Agenda
Village of Arlington Heights
Design Commission
Community Room, 3rd Floor

Arlington Heights Village Hall
33 S. Arlington Heights Road
Arlington Heights, IL 60005
March 29, 2016
6:30 PM

**MINUTES OF
THE VILLAGE OF ARLINGTON HEIGHTS
DESIGN COMMISSION MEETING
HELD AT THE ARLINGTON HEIGHTS MUNICIPAL BUILDING
33 S. ARLINGTON HEIGHTS RD.
MARCH 8, 2016**

JOB NO.	16002
DATE:	01-11-16
DRAWN BY:	MDS
SCALE:	AS NOTED
SHEET NO.	3
REAR ELEVATION RIGHT SIDE ELEV.	OF 9

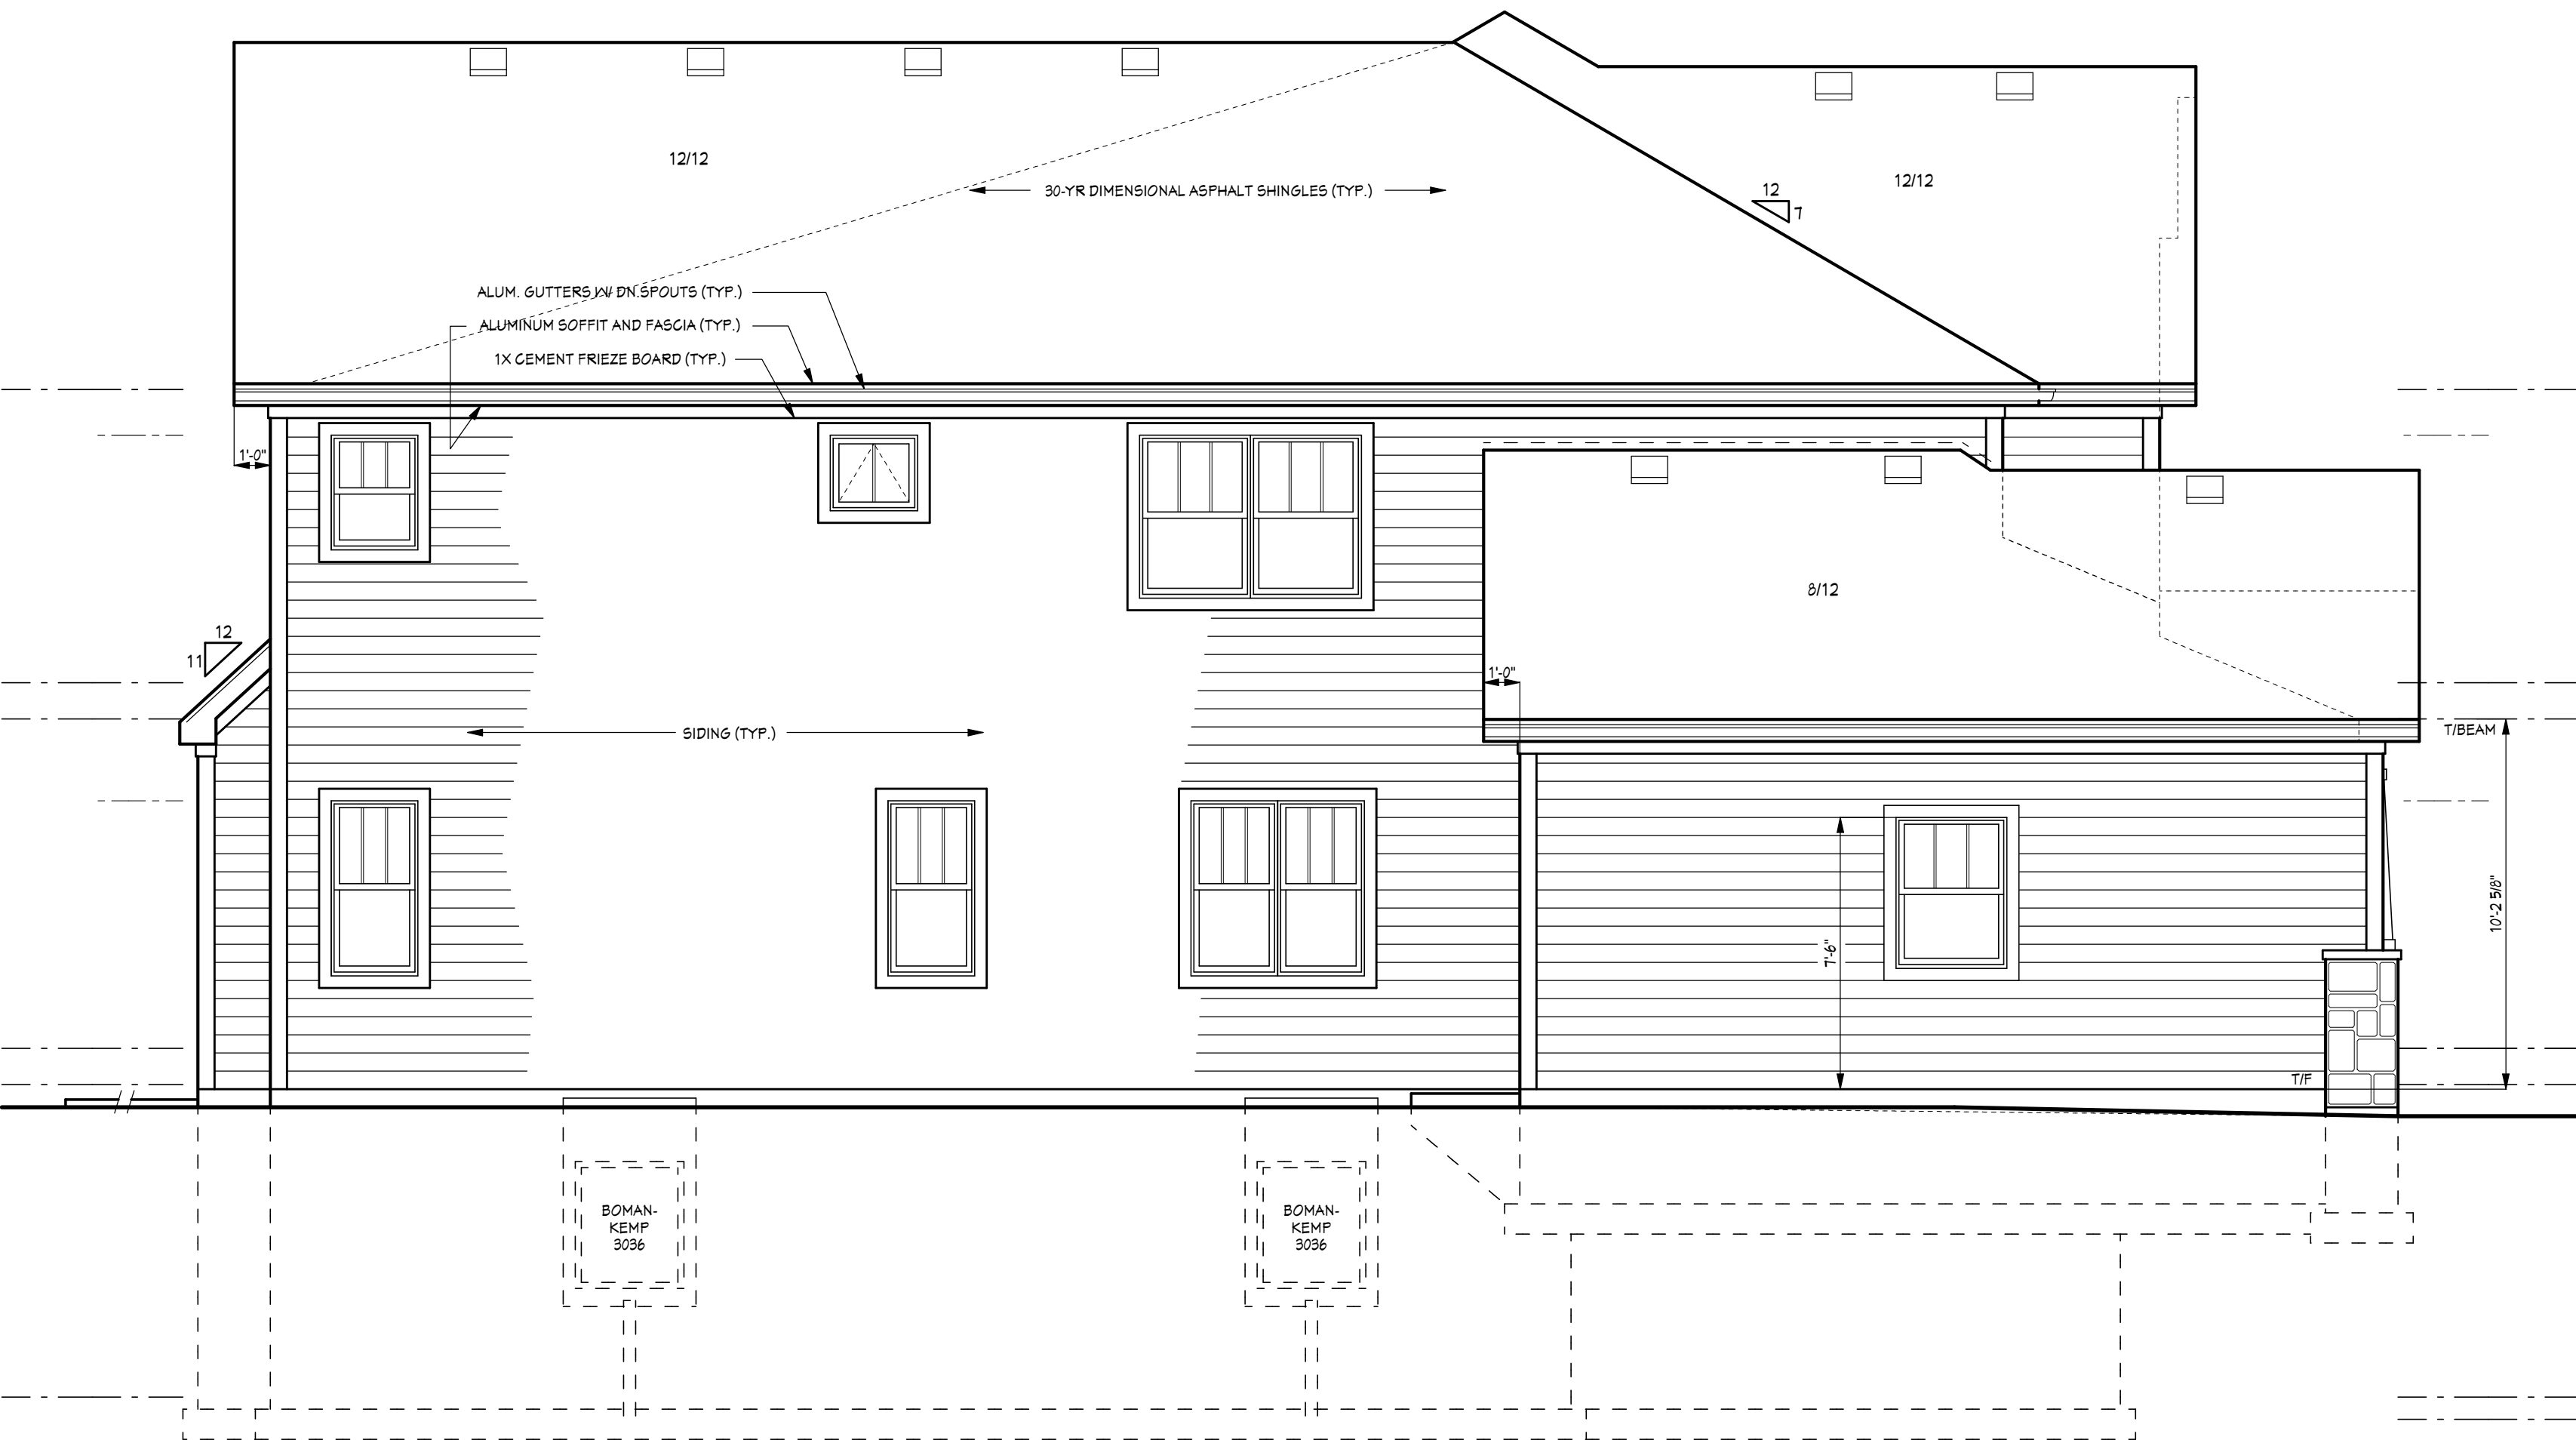
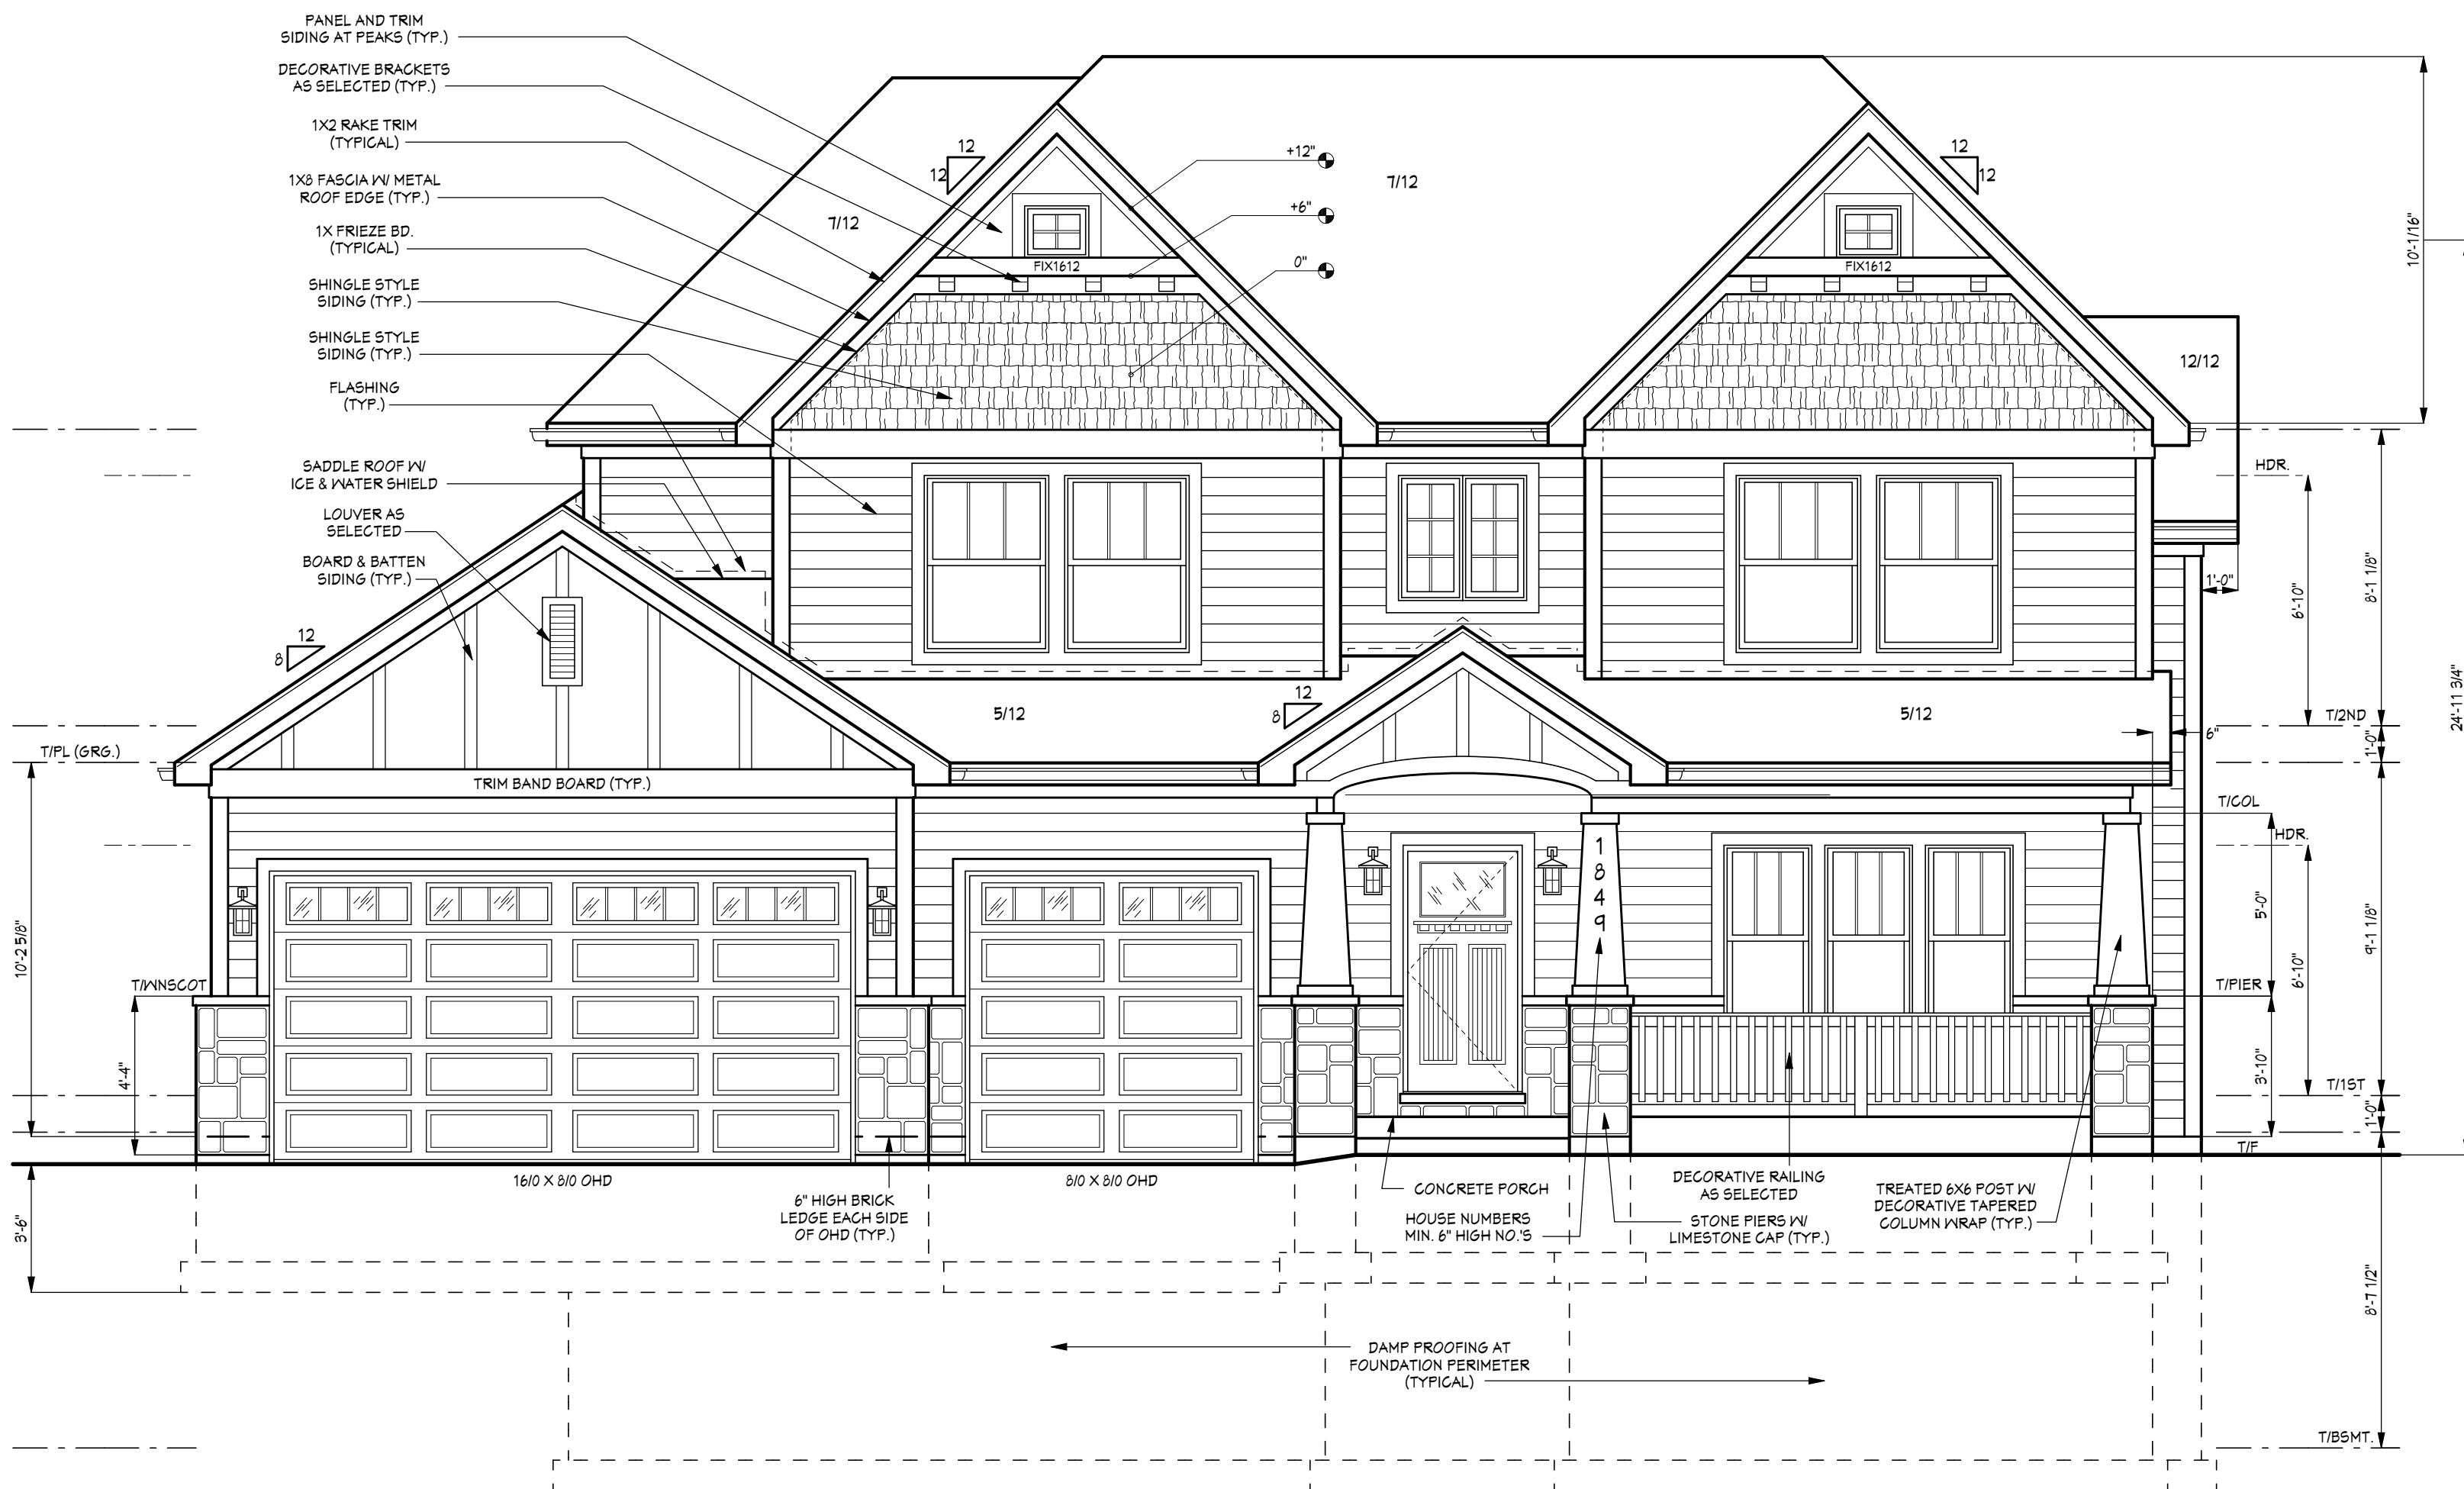
1. Add additional windows to the side elevations to help break up the wall area.
2. This review deals with architectural design only and should not be construed to be an approval of, or to have any other impact on, any other zoning and/or land use issues or decisions that stem from zoning, building, signage or any other reviews. In addition to the normal technical review, permit drawings will be reviewed for consistency with the Design Commission and any other Commission or Board approval conditions. It is the architect/homeowner/builder's responsibility to comply with the Design Commission approval and ensure that building permit plans comply with all zoning code, building permit and signage requirements.
3. Compliance with all applicable Federal, State, and Village codes, regulations and policies.
